Temperature sensors on APAs

Introduction

- Few problems have been observed in RTD kits sent to Daresbury and Chicago. Many apologies to both for the inconveniences
- Kits not yet installed have been returned to IFIC and are being carefully inspected and repaired
- The path forward
 - 1.Characterise observed problems
 - 2.Repair existing kits
 - 3.Changes in production procedures for new kits
 - 4.Changes in QA/QC procedures for repaired/new kits
- These items will be covered in this talk

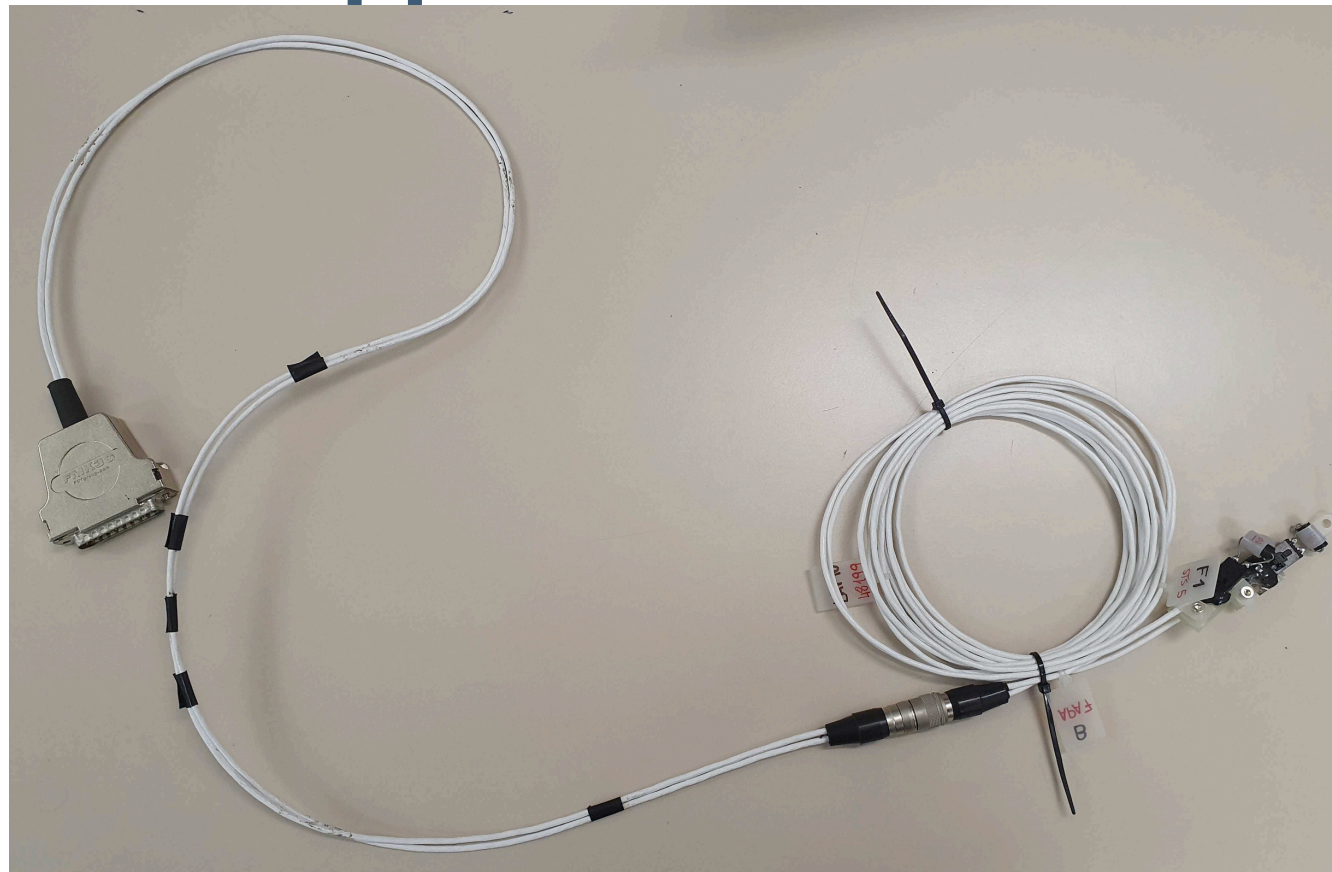
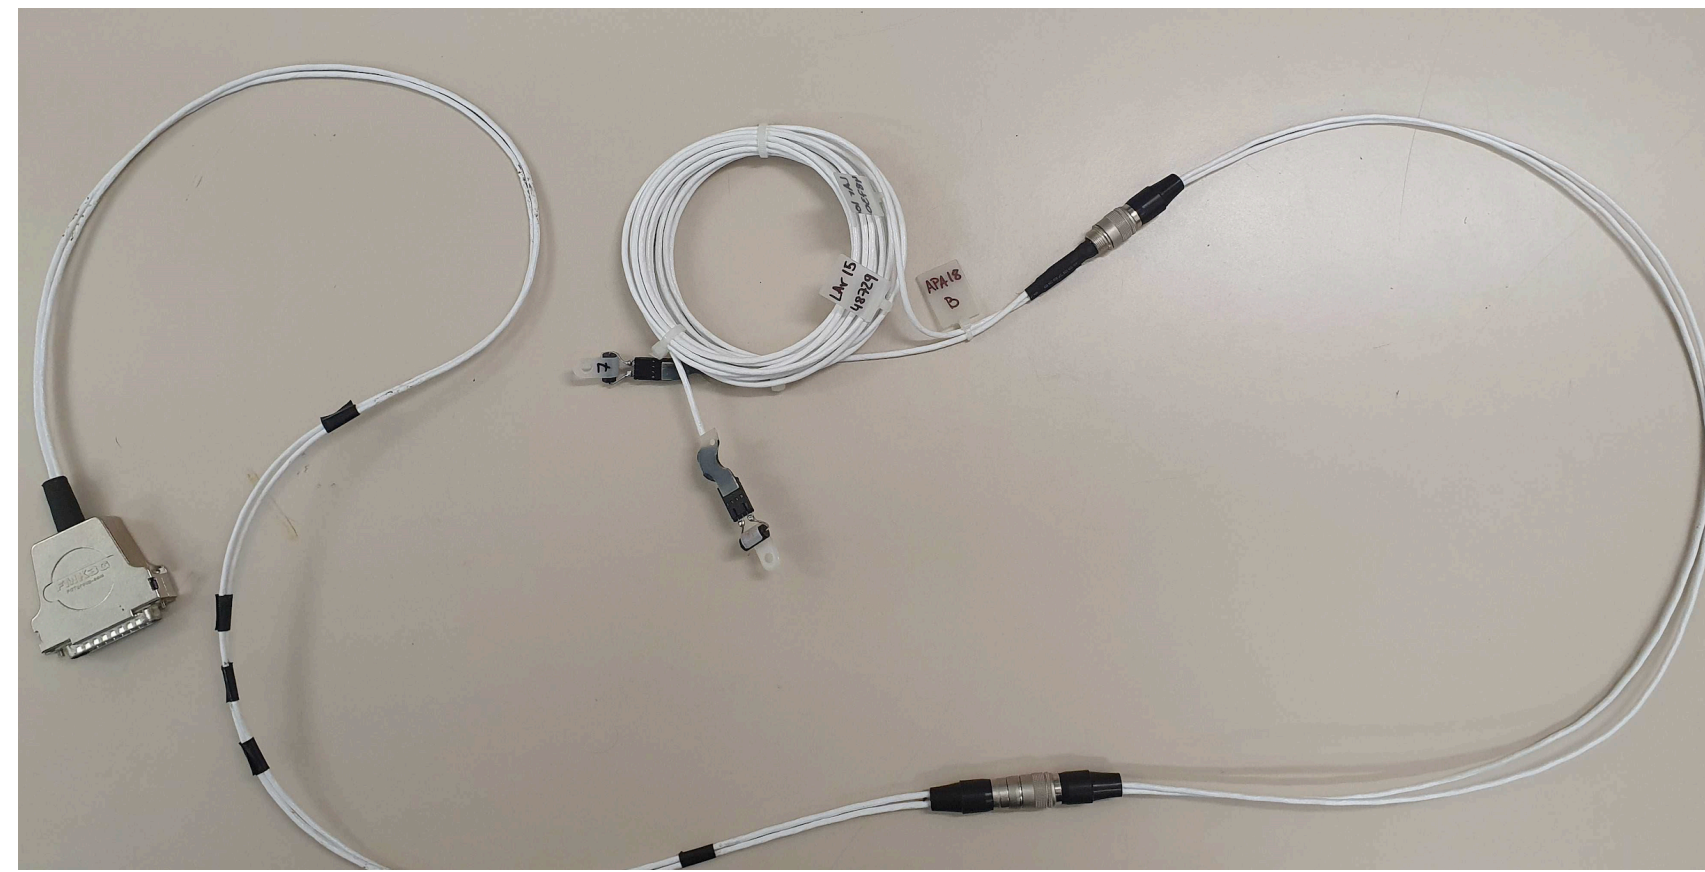
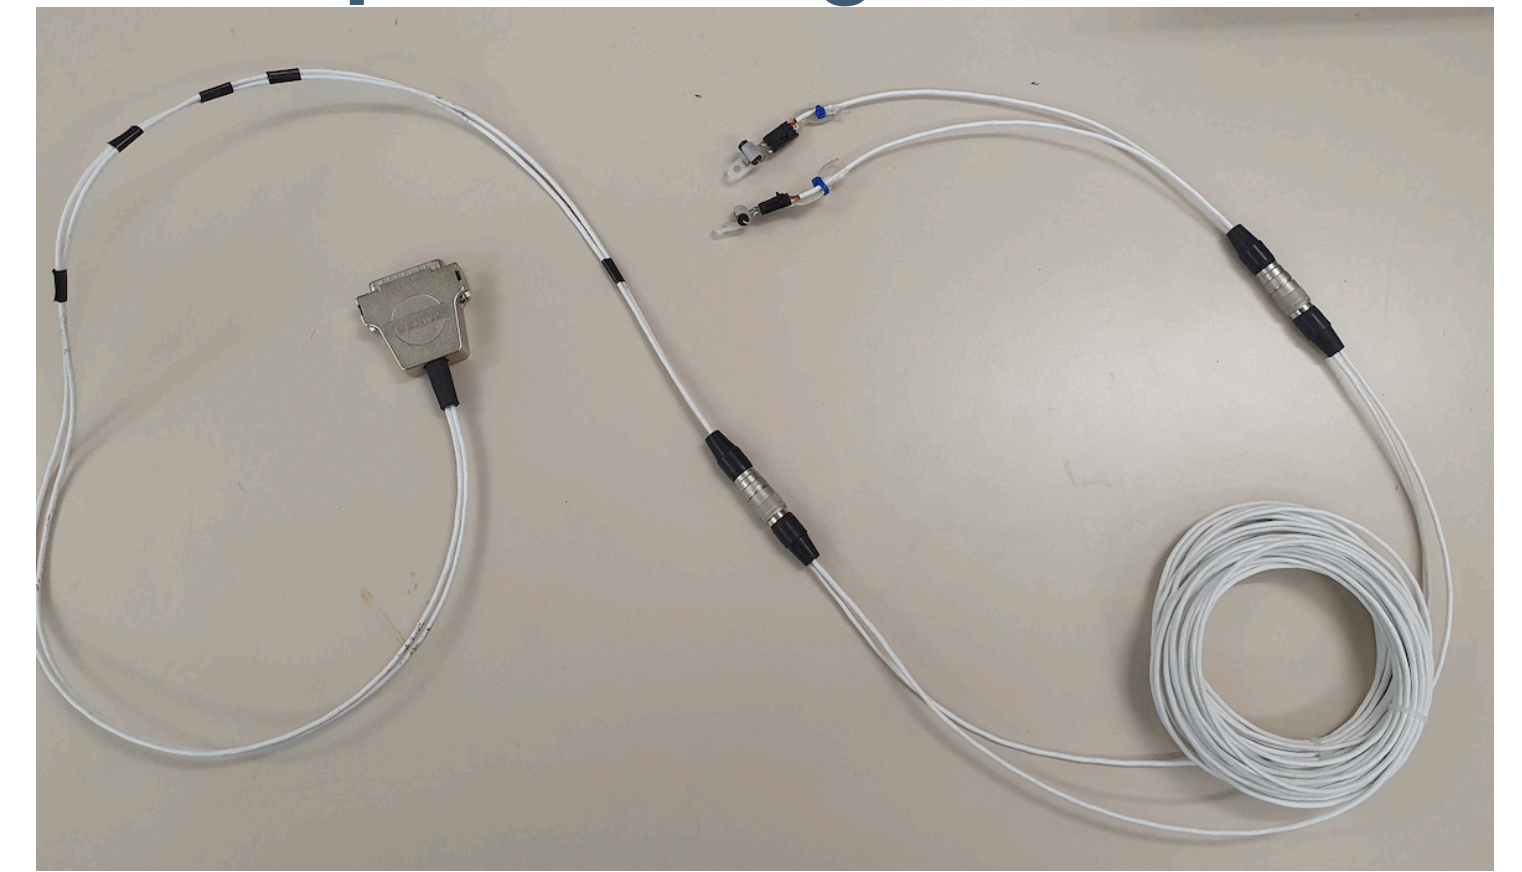
- Daresbury has reported electrical failures for many RTD cables
- We have retested all cables at IFIC and confirmed there is not a single failure
- Electrical tests were not foreseen at APA production factories and therefore there was not written procedure
 - All tests were done at IFIC before shipment, both in cold and in warm.
 - Probability of failure after shipment was estimated to be negligible
- We have now reconsidered this decision and will provide to APA production factories with the necessary hardware to quickly perform electrical tests in all cables

- **Repair:** none
- **Changes in production:** none
- **Changes in QA/QC:** electrical tests at APA production factories before and after installation

Substitute SUBD-25 connector by a PCB with 4 copper pads, two for each RTD

Problem 2: cable tie/clamp not present

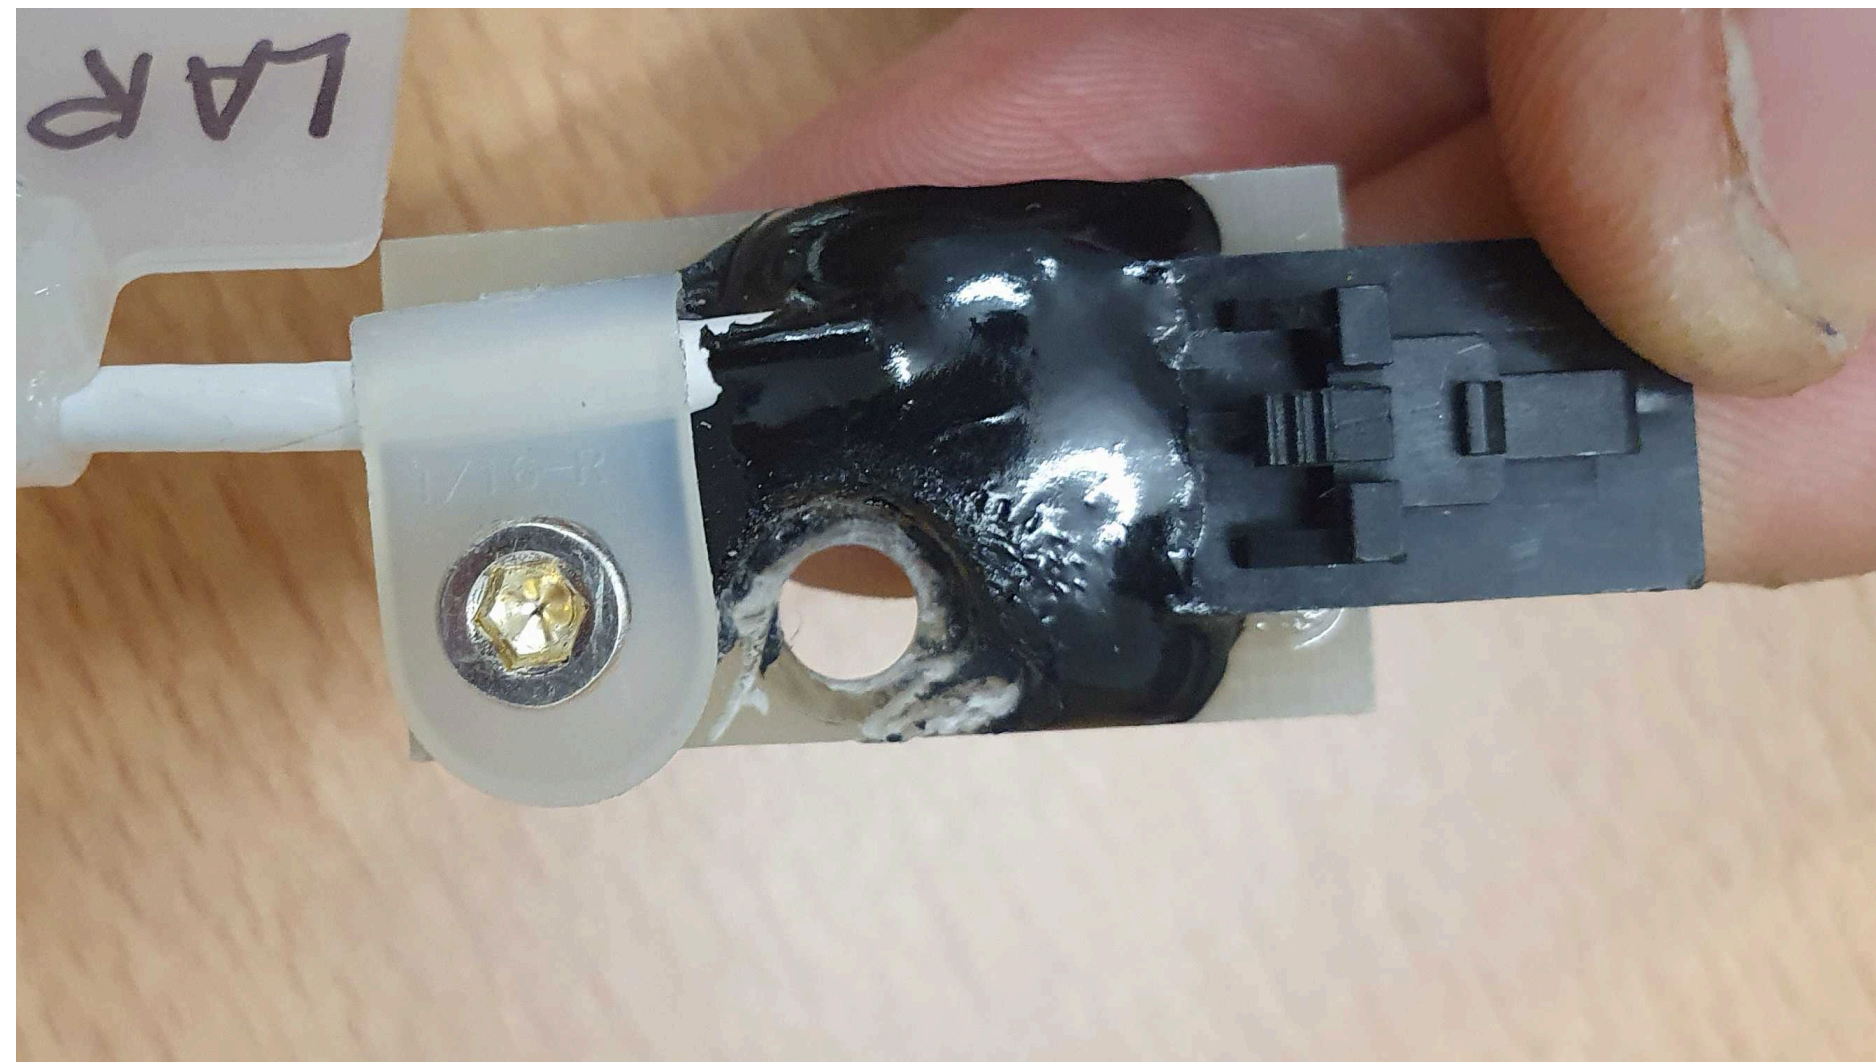
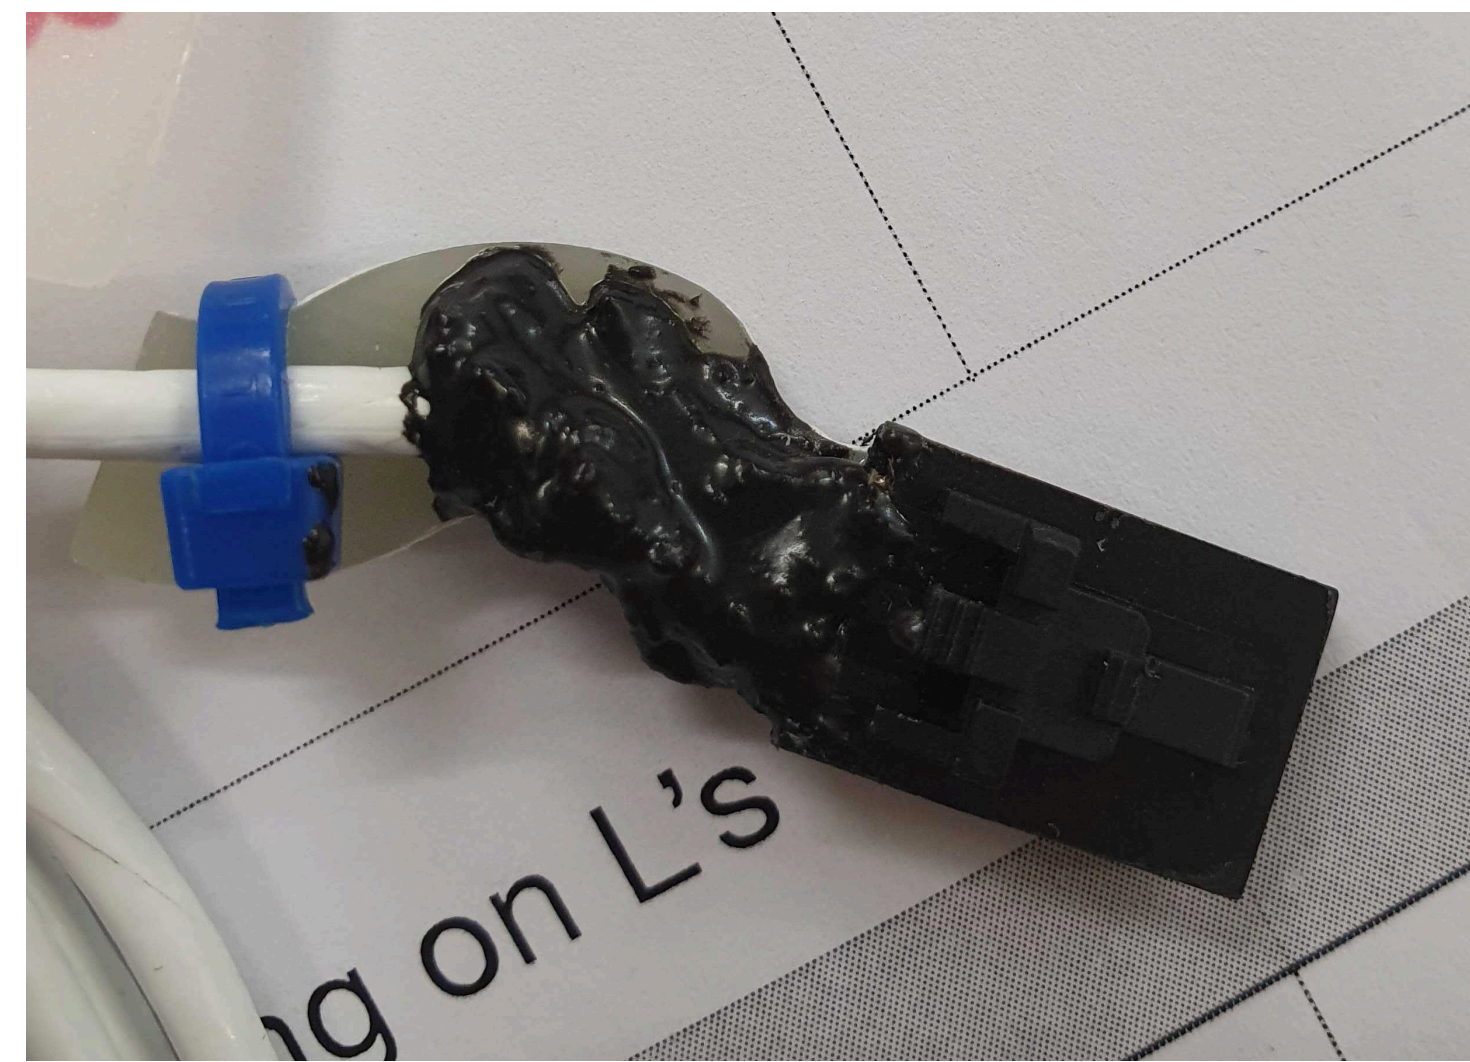
- After APA 13 we decided to remove the cable tie/clamp in order to simplify the manufacturing process
- However we have noticed that the assembly is more robust with it
- In consequence, these elements will be restored

Cable clamp for upper APAs

Cable tie for lower APAs

Problem 3.a: Epoxy quality

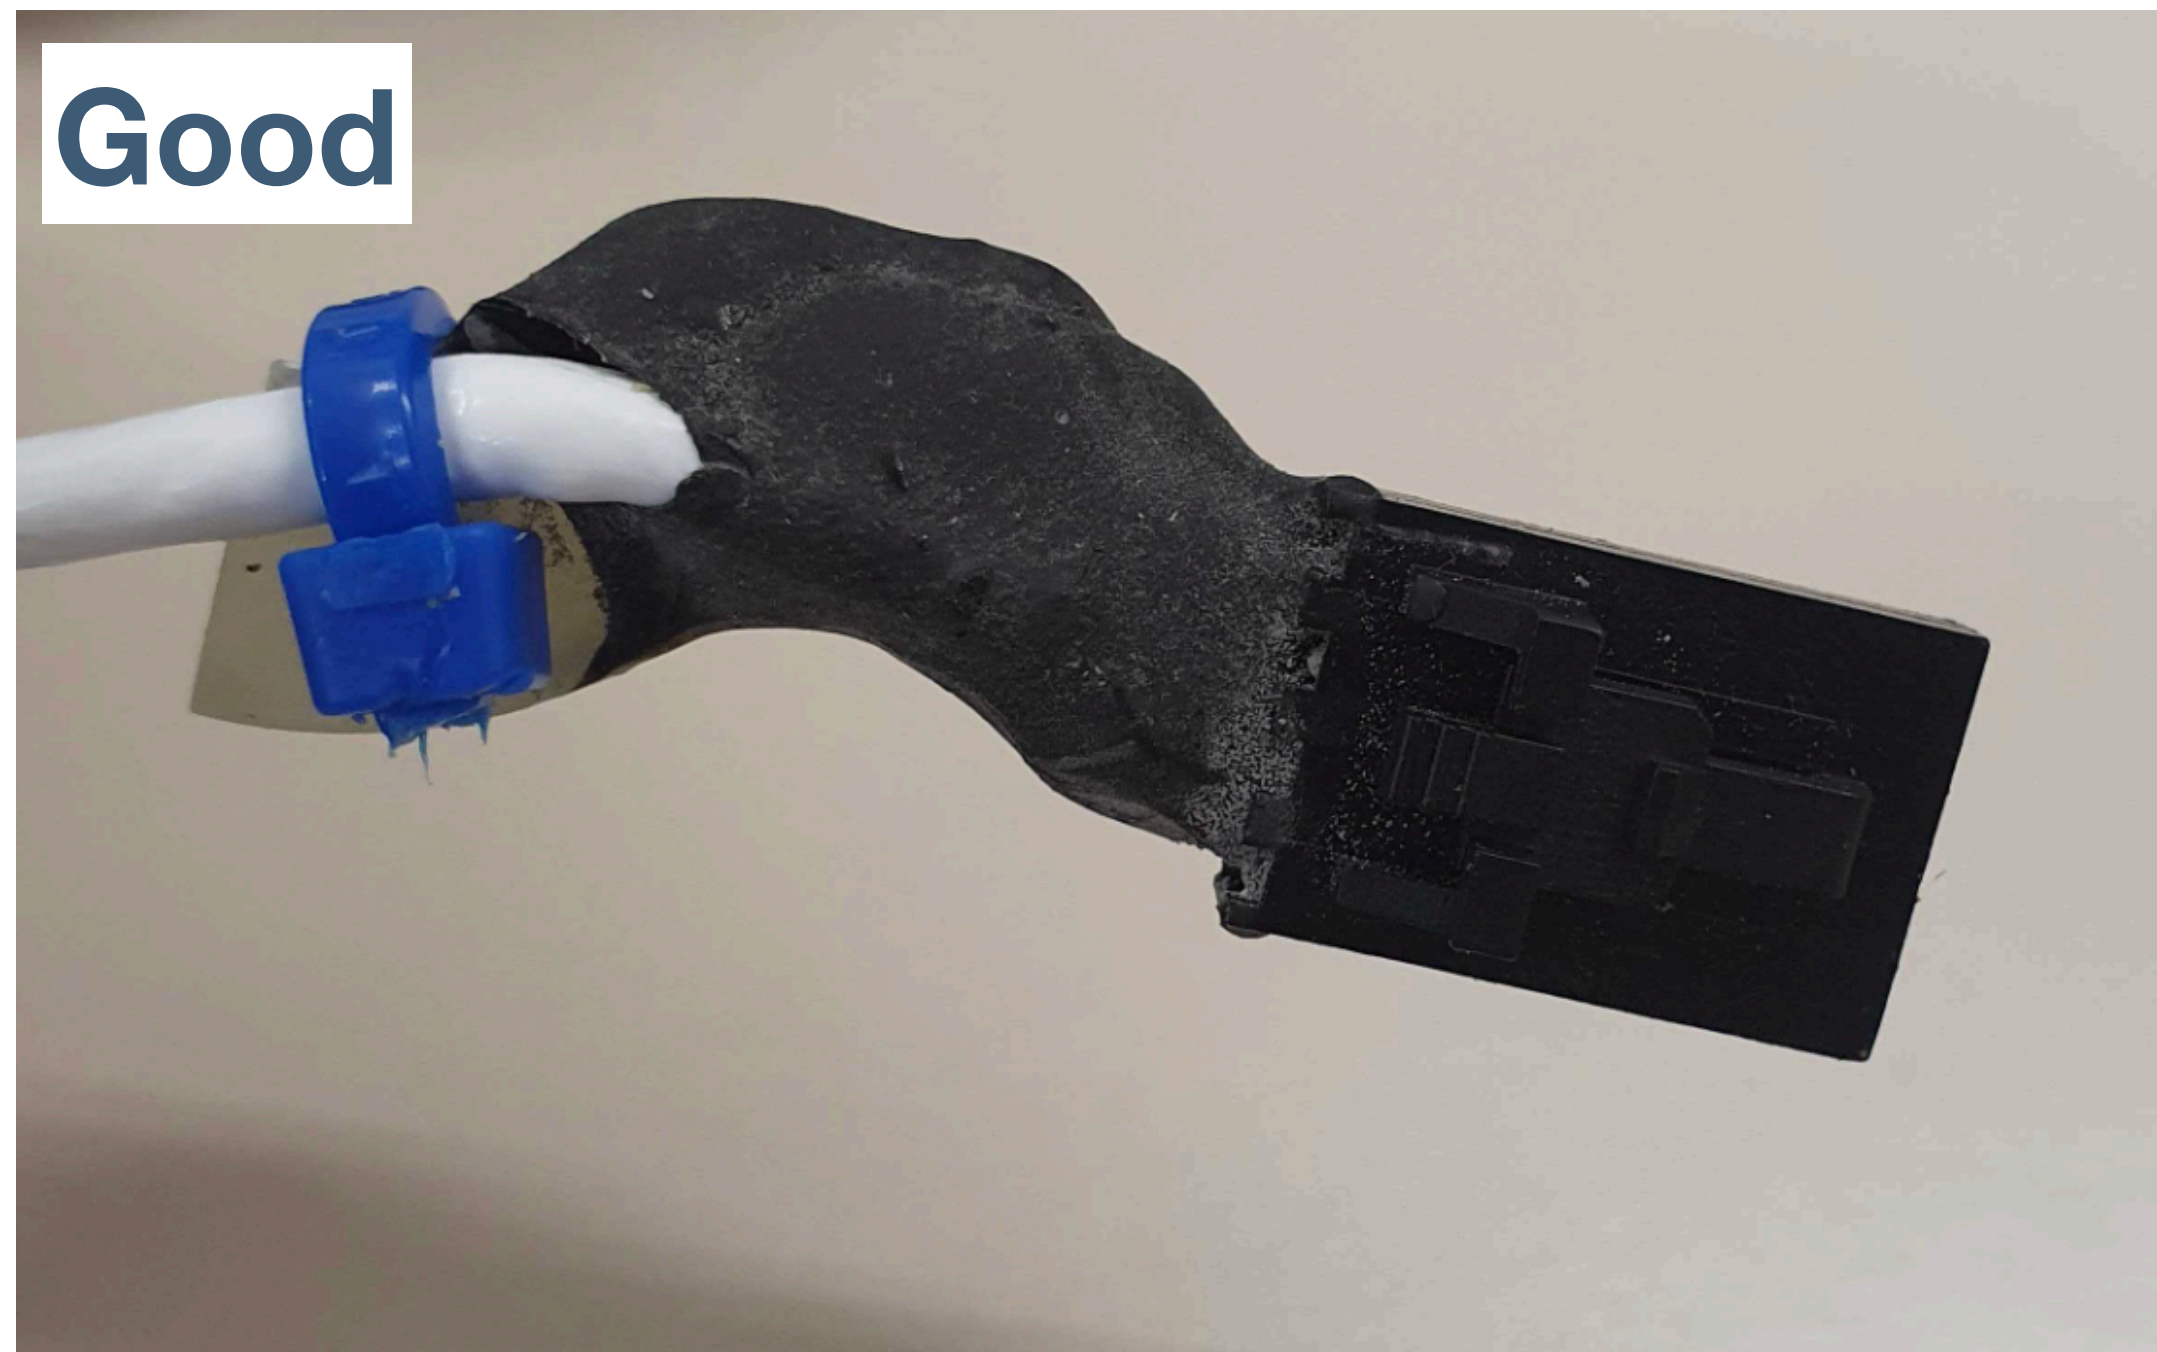
- Sometime it is only aesthetics
- **Repair:** add more epoxy with proper distribution
- **Changes in production:** remove bubbles before applying epoxy
- **Changes in QA/QC:** look at aesthetics
